Access Compliance Report

Public Rights-of-Way

(Curb Ramps)

Intersection ID: 28656	Main Street: CAVETT_CT	Cross Street: HAMPTON_PLACE_DR	Location: SW
ADA ID: EF559A9D12E7	Ramp Type: Perp	Initial Pass/Fail: Fail	Overall Compliance: No
		Severity Score: 25

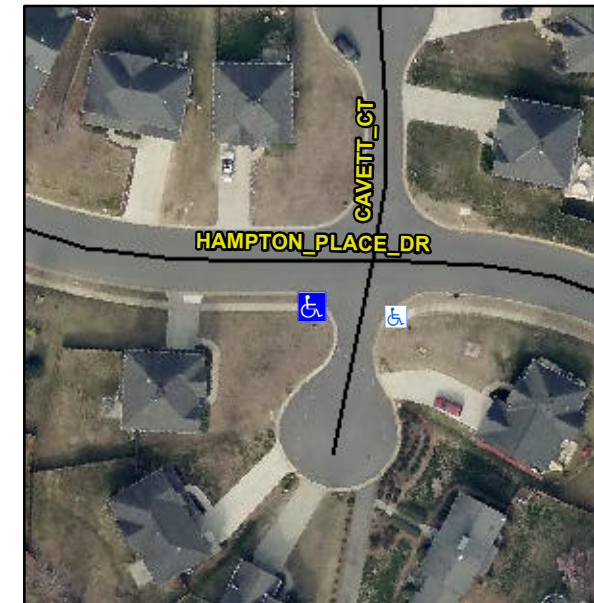
R304.5.3

Compliance	Description	Data	Compliance	Description	Data
N/A	Ramp Length (in)	42.5	Yes	Ramp Slope (%)	5.8
Yes	Ramp Width (in)	48.0	No	Ramp XSlope (%)	7.1
N/A	Flare Type LT	N/A	N/A	Flare Type RT	N/A
N/A	Flare Slope LT (%)	N/A	N/A	Flare Slope RT (%)	N/A
N/A	Flare Traversable LT?	N/A	N/A	Flare Traversable RT?	N/A
N/A	Landing Length (in)	N/A	N/A	DWS Provided?	N/A
N/A	Landing Width (in)	N/A	N/A	DWS Contrast?	N/A
N/A	Landing Slope (%)	N/A	N/A	DWS Length (in)	N/A
N/A	Landing X Slope (%)	N/A	N/A	DWS Full Width?	N/A
N/A	Landing Curb? (Y/N)	N/A	N/A	DWS Offset (in)	N/A
N/A	Shared Landing?	N/A			
N/A	Gutter Ponding?	N/A	N/A	Gutter Slope (%)	N/A
N/A	Gutter Lip Ht (in)	N/A	N/A	Gutter X Slope (%)	N/A
N/A	Painted X Walk1?	No	N/A	Painted X Walk2?	N/A
	X Walk 1 Direction	To E		X Walk 2 Direction	N/A
N/A	X Walk 1 Width (in)	N/A	N/A	X Walk 2 Width (in)	N/A
	X Walk 1 Slope (%)	7.4		X Walk 2 Slope (%)	N/A
	X Walk 1 X Slope (%)	2.6		X Walk 2 X Slope (%)	N/A

Remove & Replace Entire Ramp.
